## Ground for Refusal

# 10,14,14a Stanhope Road SSDA Submission

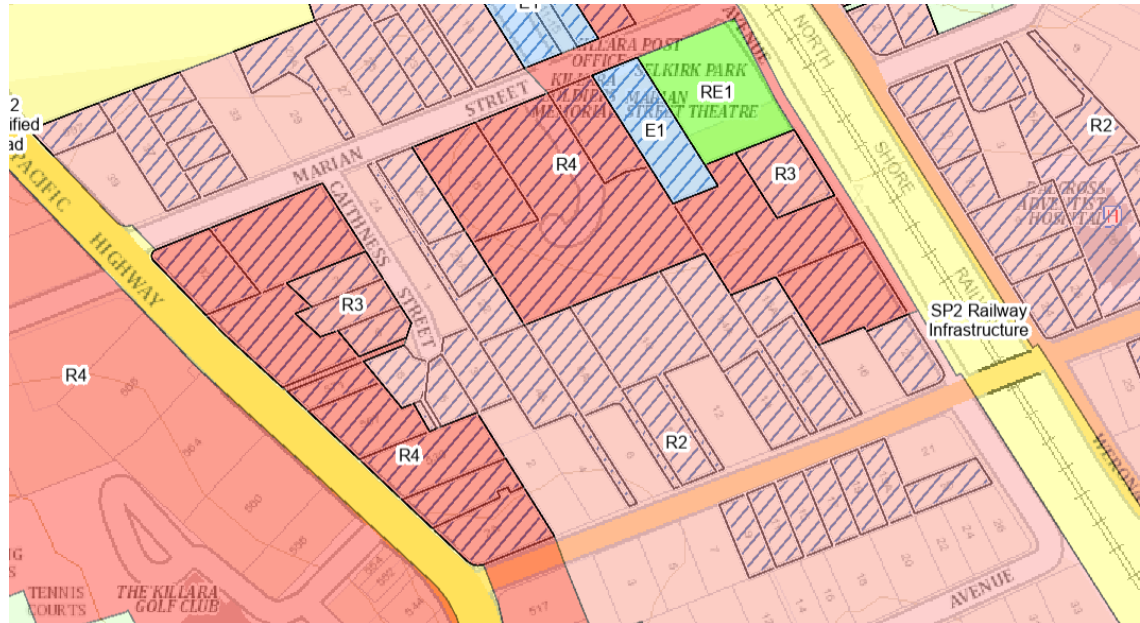
The proposal fails to address the future context of the precinct which is to remain low scale residential in character. The Councils TOD's planning excludes the proposed form of development. Approval will result in an isolated series of 10 storey building in an area designated to 2 storey domestic.

**It out of context with the current and future urban forms**

12 and 18 Stanhope Road are Heritage Items under the LEP

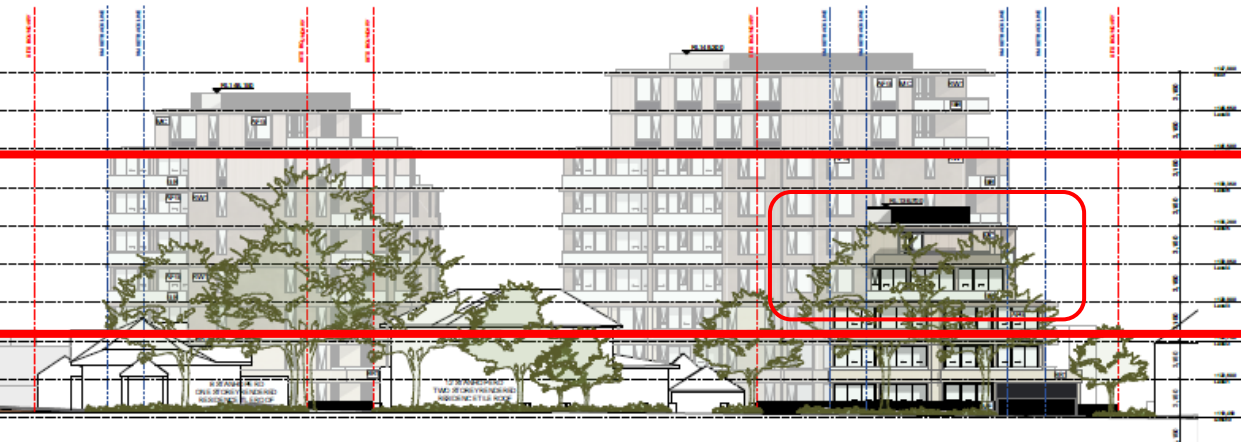
The proposal superficially considers the impact on the Heritage Conservation area and the Heritage Items, particularly 12 and 18 Stanhope Road. The proposal removes a 1-2 storey Federation era and replaces it with a 4-5 storey modern apartment building, a form out of context and incongruous architecturally.

**Heritage is only  
superficially  
considered at best**

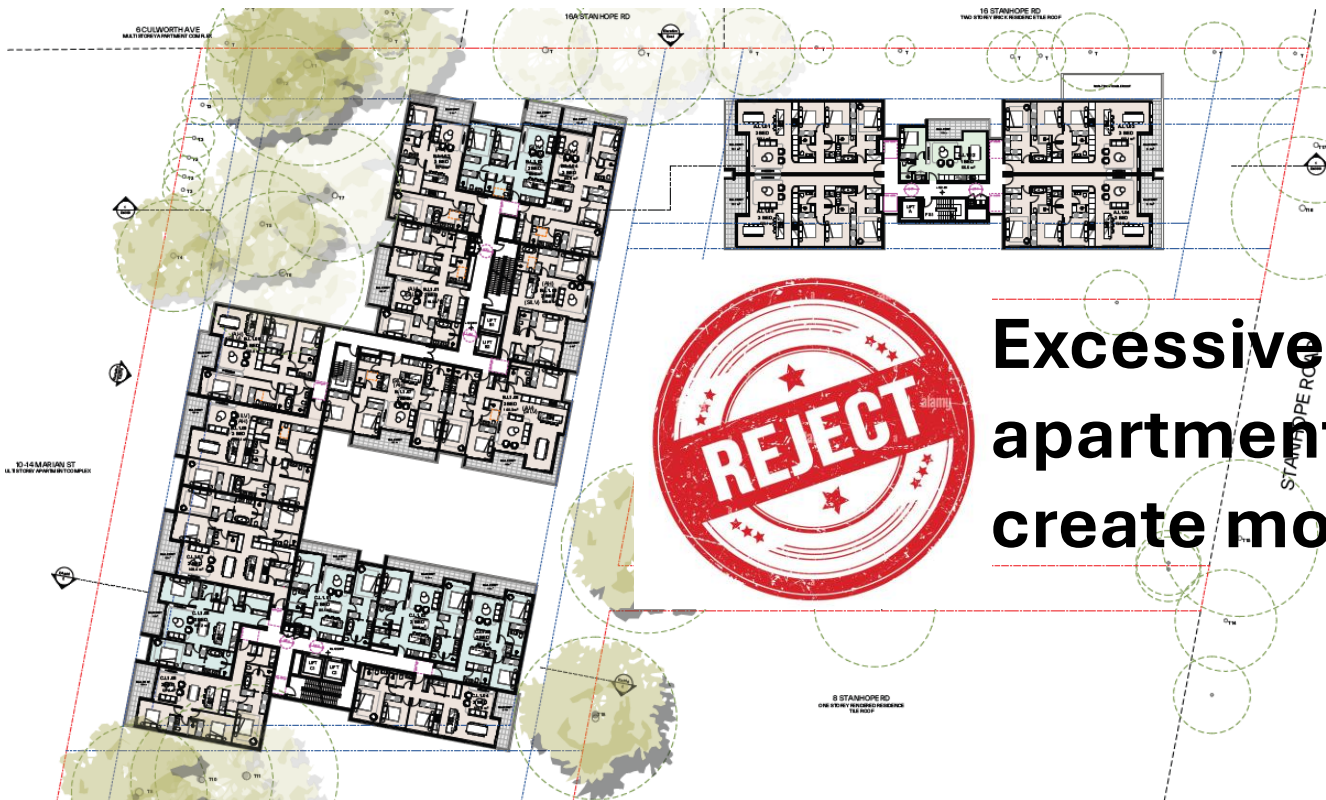
The buildings are monolithic and represent over development of the site. The footprint is excessive leading to large unarticulated facades, bulky buildings that are out of scale and character with the area. The setbacks are at the minimum under the ADG exacerbating poor articulation. The lesser number of apartments per floor is needed to improve the scheme and improve the architectural response.

**Excessive number of apartments per floor create monolithic forms.**
